Division of Reclamation,
Mining and Safety

**RE: Adequacy Review, 110(2) Hardrock Amendment Application (AM-01)
Scott Blue II, Permit No. M-2007-031**

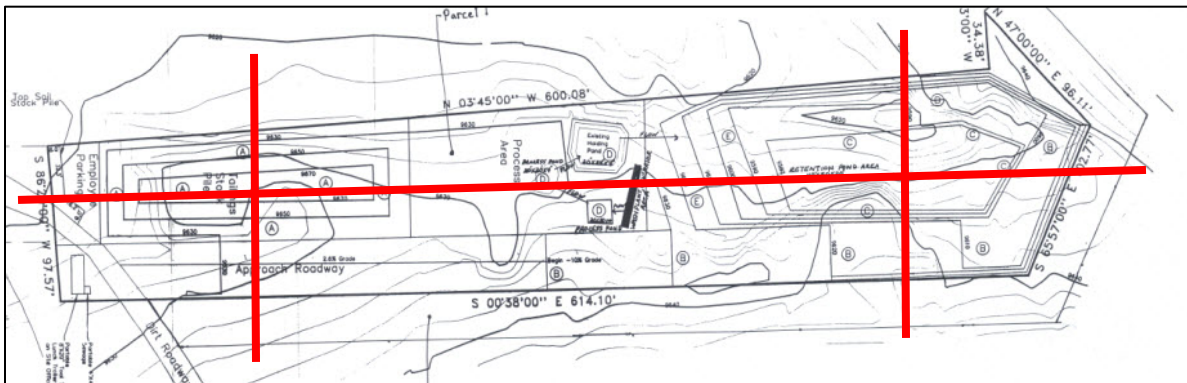
4. Please submit three cross sections, two east-west and one north-south, which depict the off-site lands, permit boundary, pit, and tailings stockpile during the mining operation. Please refer to the image below for the requested alignments of these cross sections.

8. Similar to the request in Adequacy Item #4, please submit the same three cross sections which depict the final topography as proposed in the reclamation plan and reclamation plan map. The Applicant may want to submit this information on the same cross sections which will show proposed maximum mining topography and proposed final reclamation topography.
